Application for Works Approval

Works Approval Number	W6495/2021/1
Applicant	Robe River Mining Co. Pty Limited
ACN	107 210 248
File Number	DER2020/000619
Premises	Mesa J Mineral Lease (ML) 248SA Section 104 As defined by the Premises maps attached to the issued works approval
Date of Report	19 August 2021
Proposed Decision	Works approval granted

MESA J

Figure 1 Proposed works at Mesa J TSF3. Pink line denotes TSF3 proposed boundary, blue line depicts waste fines pipeline

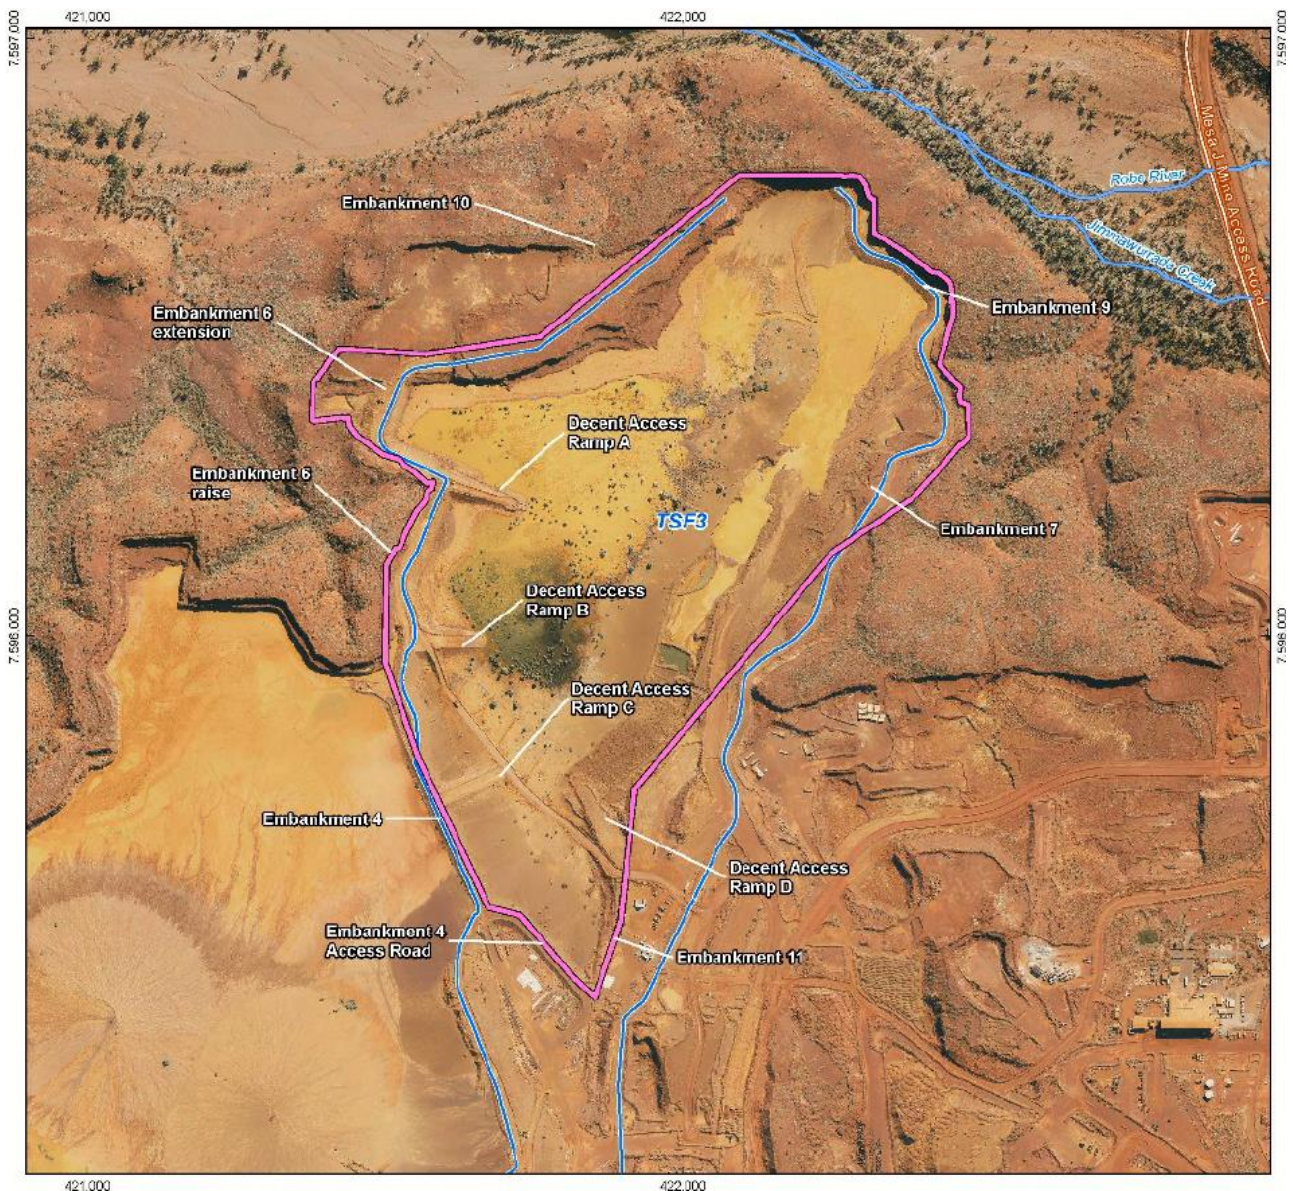
Condition	Summary of applicant's comment	Department's response
<p>Condition 1 – Table 1</p> <p>1. In pit tailings storage facility TSF3</p>	<p>The applicant requests that Table 1 be revised as follows: 1. In pit tailings storage facility TSF3 Modifications.</p>	<p>Amended</p>
	<p>Deposition of unthickened tailings from Embankment 11 is considered overly prescriptive</p>	<p>Amended – unthickened removed</p>
	<p>Location and Number of Spigots /Discharge Points: Tailings are proposed to be deposited into TSF3 from one or more tailings discharge points, altered as required to support the deposition strategy. Reference to the specific location and number of spigots is considered overly prescriptive and does not allow for the adaptive management of tailings deposition during operation to provide more capacity for tailings storage, manage the beach slopes and maintain the decant pond to the south of the facility.</p> <p>Deposition is proposed to be managed through the implementation of the revised Operating Manual (which includes a deposition plan) and as such, an amendment to Table 1 is requested to allow deposition from tailings discharge points located along the embankments at the indicative locations shown in Figure 2.</p>	<p>Amended - Deposition via one or more tailings discharge points located along the embankments at the locations shown in Figure 2</p>

Condition	Summary of applicant's comment	Department's response
Condition 21 (d)	Administrative error The applicant requests that Condition 21 (d) be revised to remove the reference to WFC3A.	Amended to reflect TSF3 and TSF 5.
Figure 1, Figure 2 and Figure 5	Administrative changes	Amended
Schedule 2	Applicant provided prescribed premisses coordinates	Amended
Applicant response to second draft works approval		
Condition	Summary of applicant's comment	Department's response
Details, Location and Capacity of Decant Pumping System	Decant access ramps allow access for decant return water pumps ('TruFlo 200' Pumps with capacity to pump up to 200L/s through floating 'turrets' attached to their inlets) to facilitate removal of water from the decant pond. Pumping rates will be varied as required to maintain a shallow decant pond (pond elevation that provides sufficient freeboard to meet design requirements and reduce potential seepage) in the south of the facility, away from the northern embankment. There is no existing decant infrastructure in TSF5 as this facility is not currently in use. The decant system from TSF3 would be relocated to TSF5 if / when deposition into this facility is planned to recommence.	Noted

Figure 2: Mesa J TSF5 – red line depicts TSF 5 boundary, blue line depicts waste fine pipeline.

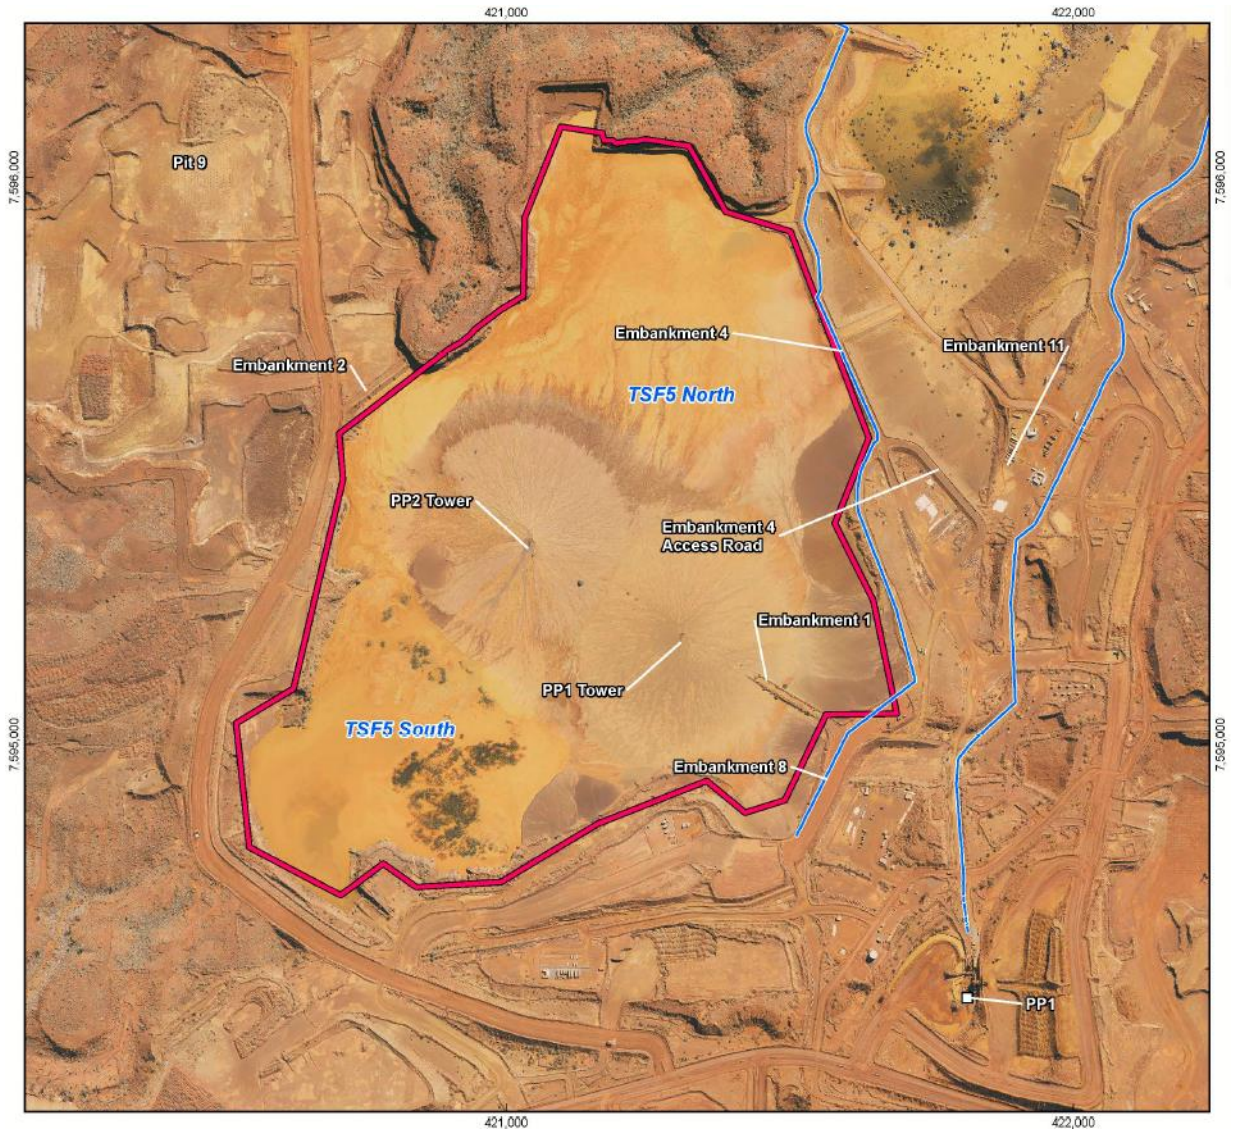
Conditions 4, 5, 13, 15 and Figures 2 and 5	Administrative corrections	Amended
Condition 12, 20 and 21	-	Conditions amended to align with standard DWER guidelines for time limited operation (TLO) timeframes. The changes were discussed and agreed with applicant on 19/08/2021.

Figure 4: Potential seepage path between TSF3 and Robe River alluvium.

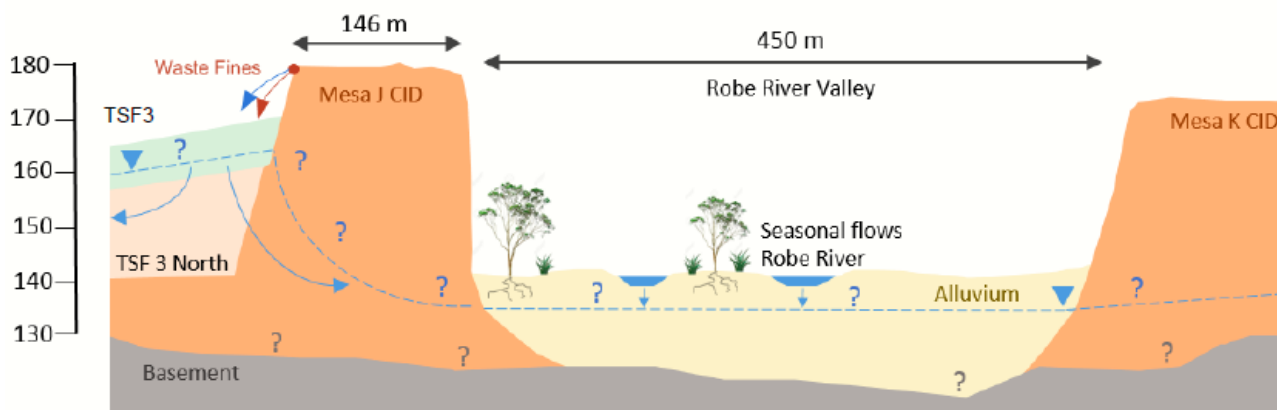
The current monitoring bore network is considered inadequate for monitoring seepage movement directly between the northern extremities of TSF3 and the river frontage. There are no bores in place to provide seepage monitoring coverage over this area, which marks the closest extent between the TSF network and the Robe river. Any fugitive contaminants seeping into the river from the TSF through this location are unlikely to be detected or intercepted. A

network of recovery and monitoring bores should be installed around the TSF perimeter, with focus on the northern side facing the Robe River to intercept seepage.

Appendix 3: Mesa J monitoring bores locations

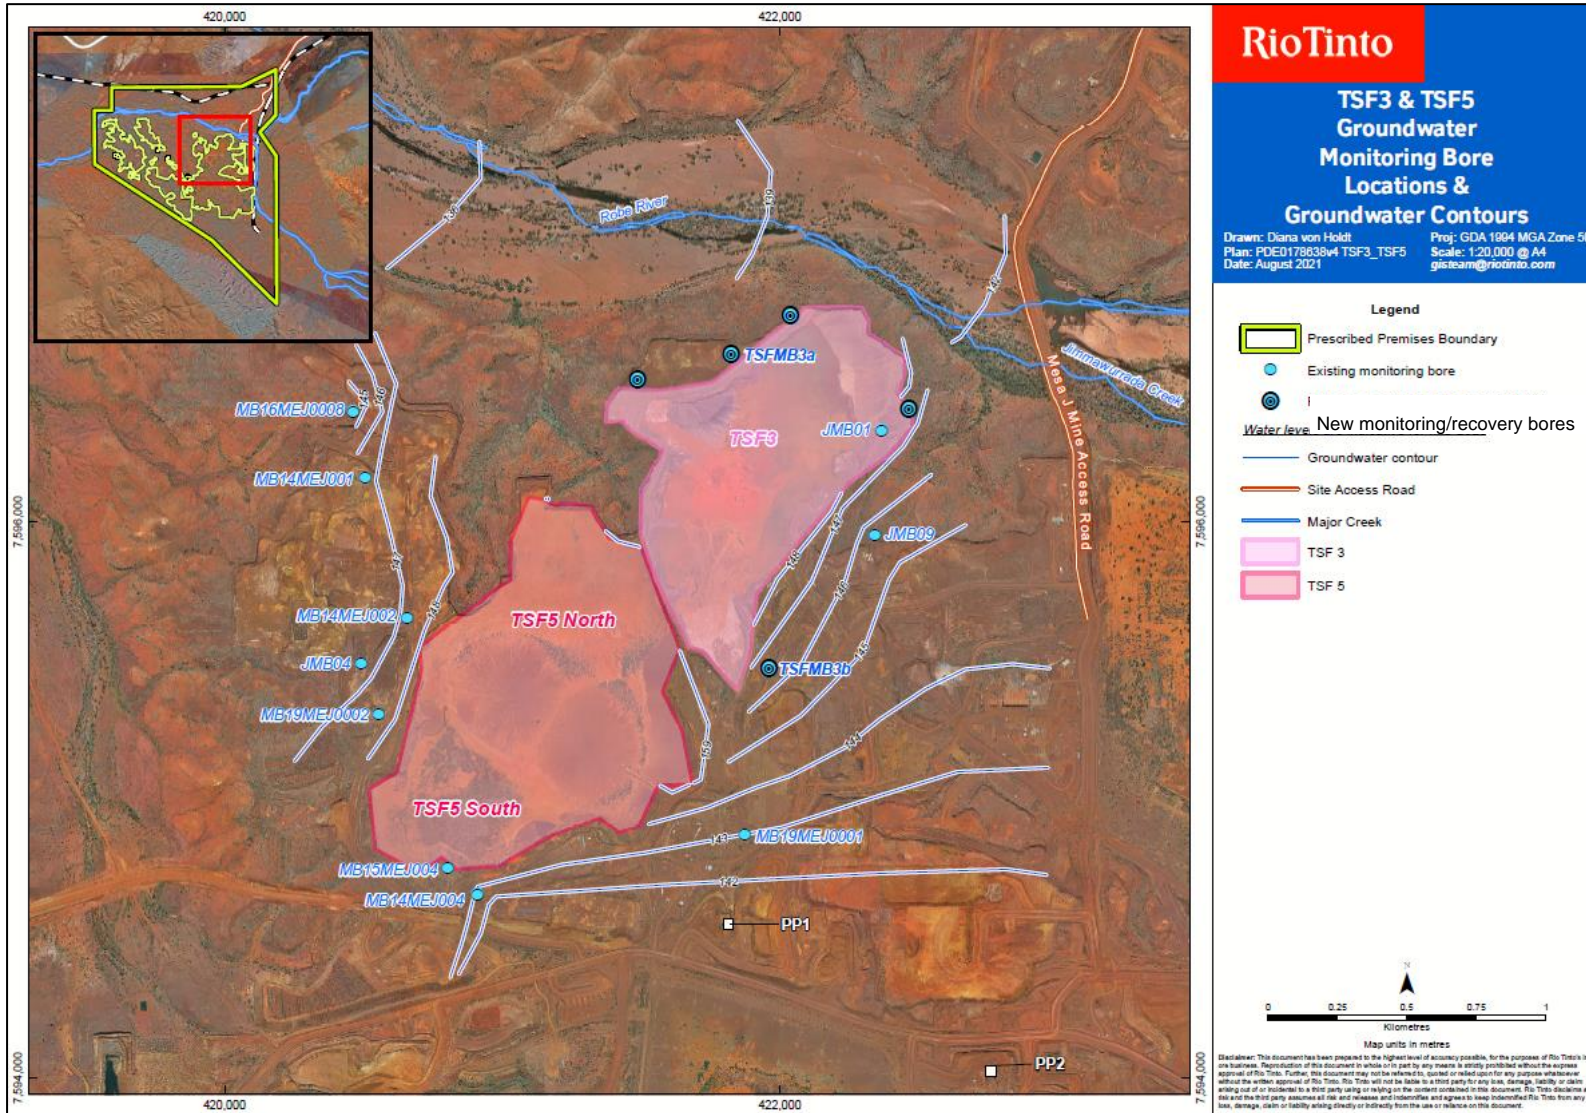
<p>Table 5 of the draft Works Approval also requires the works approval holder to install and monitor five new bores, as indicated in Figure 8.</p> <p>Of the five new bores, one will be located downstream of Embankment 10 (TSFMB3a) and one will be located downstream of Embankment 11 (TSFMB3b). TSFMB3a and TSFMB3b are already accounted for within Table 5 and as such, the Licensee requests that the table be revised to require three new bores in addition to TSFMB3a and TSFMB3b as indicated in Figure 8 (Attachment 2).</p> <p>Of the three new bores required (in addition to TSFMB3a and TSFMB3b), the westernmost bore (Location 1) is located within a significant heritage area (Attachment 3). Access to this region is also expected to be challenging, with limited access through treacherous terrain, requiring tracks to intersect other heritage sites. The extensive consultation and assessment timeframe for relevant heritage approvals required to access Location 1 has been assessed and is anticipated to be at least 2 years.</p>	<p>Given the extent of the DPLH sites adjoining the TSF3 site the department understands the difficulties to install monitoring/recovery bores on the escarpment. The terrain on the escarpment would also make it very hard to mobilise equipment without further disturbance to these areas.</p> <p>The department accepts the new bore sites proposed by the applicant, although they are likely to consistently report elevated levels of seepage, given their proximity to the TSF. This will necessitate frequent pumping and recovery, with the recovered seepage requiring redispersal further away from the TSF perimeter.</p> <p>The inability to install monitoring bores further downgradient of the TSF (towards the river) means it will be hard to detect seepage plumes that make it past these monitoring/recovery bores. Any contamination</p>

Condition	Summary of applicant's comment	Department's response
	<p>The applicant requests that the new bore is located slightly east of Location 1, avoiding significant heritage areas while still providing groundwater monitoring data downgradient of TSF3.</p> <p>Of the three new bores required (in addition to TSFMB3a and TSFMB3b), the northernmost bores (Locations 3 and 4) are within the mesa façade with significant environmental and heritage values.</p> <p>The northern façade of the mesa, adjacent to the Robe River, was specifically excluded from Ministerial Statement 1141 so as to ensure the preservation of the escarpment for the protection of environmental values (these escarpments support caves, gorges, gullies and breakaways that represent critical habitats for threatened species including the Northern Quoll, Pilbara Leaf-nosed Bat, Ghost Bat, and Pilbara Olive Python) as well as to maintain the mesa façade for the protection of heritage values (including both amenity and significant rockshelters). Further information on the significance of the environmental and heritage values of the mesa façade is available within the Mesa J Revised Proposal Environmental Review Document and the Report and Recommendations of the Environmental Protection Authority (Report 1668), available at Mesa H Proposal (Revision to Mesa J Iron Ore Development) EPA Western Australia.</p> <p>Access to northern façade of the mesa is also expected to be particularly challenging, with bores (and access tracks) on sloping terrain requiring cuts into the escarpment.</p> <p>The applicant requests that new bores are located west of Location 3 and south of Location 4, avoiding the northern façade of the Mesa landform, adjacent to the Robe River to ensure the preservation of significant environmental and heritage values while still providing groundwater monitoring data downgradient of TSF3</p>	<p>will only be detected once its already in the sensitive receptor (river alluvials/ pools). A commitment to remediation of any contamination recorded in these receptors can be included in the Mine Closure Plan. Contaminated sites must be informed so that these areas can be appropriately flagged.</p> <p>The proposal to install of dual-purpose monitoring/seepage recovery bores is noted and supported.</p>
